Access Compliance Report

Public Rights-of-Way

Intersection ID: 46223	Main Street: COBLE_AV	Cross Street: PARKERS_CROSSING_DR	Location: SE
ADA ID: D6EE98BADDFD	Ramp Type: PerpDiag	Initial Pass/Fail: Fail	Overall Compliance: No
Severity Score: 8.75			
Codes/Mitigation Info/Possible Solution		Field Measurements/Component Compliance

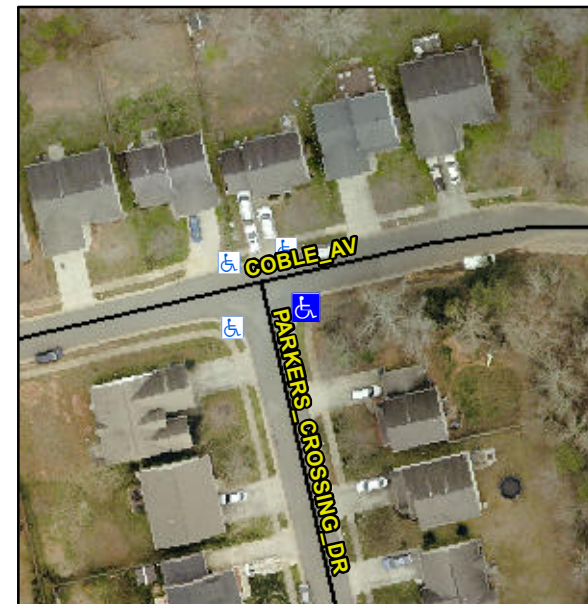
Not Found, R304.5.1

Compliance	Description	Data	Compliance	Description	Data
N/A	Ramp Length (in)	49.0	Yes	Ramp Slope (%)	5.0
No	Ramp Width (in)	36.5	Yes	Ramp XSlope (%)	0.4
N/A	Flare Type LT	N/A	N/A	Flare Type RT	N/A
N/A	Flare Slope LT (%)	N/A	N/A	Flare Slope RT (%)	N/A
N/A	Flare Traversable LT?	N/A	N/A	Flare Traversable RT?	N/A
N/A	Landing Length (in)	N/A	N/A	DWS Provided?	N/A
N/A	Landing Width (in)	N/A	N/A	DWS Contrast?	N/A
N/A	Landing Slope (%)	N/A	N/A	DWS Length (in)	N/A
N/A	Landing X Slope (%)	N/A	N/A	DWS Full Width?	N/A
N/A	Landing Curb? (Y/N)	N/A	N/A	DWS Offset (in)	N/A
N/A	Shared Landing?	N/A			
N/A	Gutter Ponding?	N/A	N/A	Gutter Slope (%)	N/A
N/A	Gutter Lip Ht (in)	N/A	N/A	Gutter X Slope (%)	N/A
N/A	Painted X Walk1?	No	N/A	Painted X Walk2?	No
	X Walk 1 Direction	To N		X Walk 2 Direction	To W
N/A	X Walk 1 Width (in)	N/A	N/A	X Walk 2 Width (in)	N/A
	X Walk 1 Slope (%)	1.4		X Walk 2 Slope (%)	1.4
	X Walk 1 X Slope (%)	1.1		X Walk 2 X Slope (%)	2.0

Remove & Replace Curb Ramp With Two New Directional Ramps or Equivalent.
